LB Note: 24.02.2021
This drawing has been updated as part of the Section 96a application. Please see adjacent notes for plan updates.

Land at Coleshill Street Miles Platting

3547A - LEV - 00 - GF - DR - A - 1400 P5

Plots A & F_Proposed Ground Floor Plan

1 Plots A and F_Ground Floor Plan
1 : 200

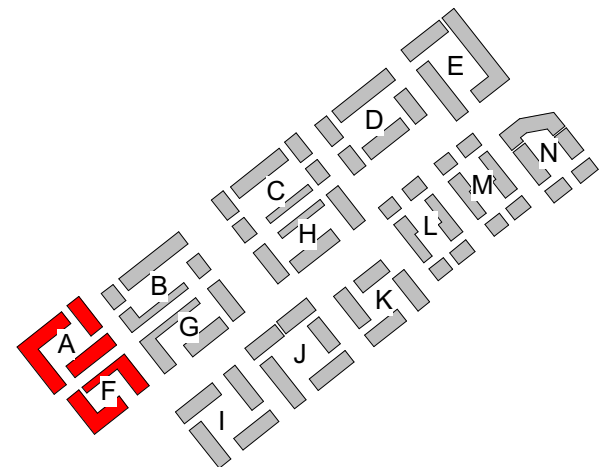
Reduction in walkway and apartment widths by 112.5mm. All apartment internal areas remain over MRQG guidance.

1 no. lift omitted to Block A

1 no. lift omitted to Block F

Reduction in walkway and apartment widths by 112.5mm. All apartment internal areas remain over MRQG guidance.
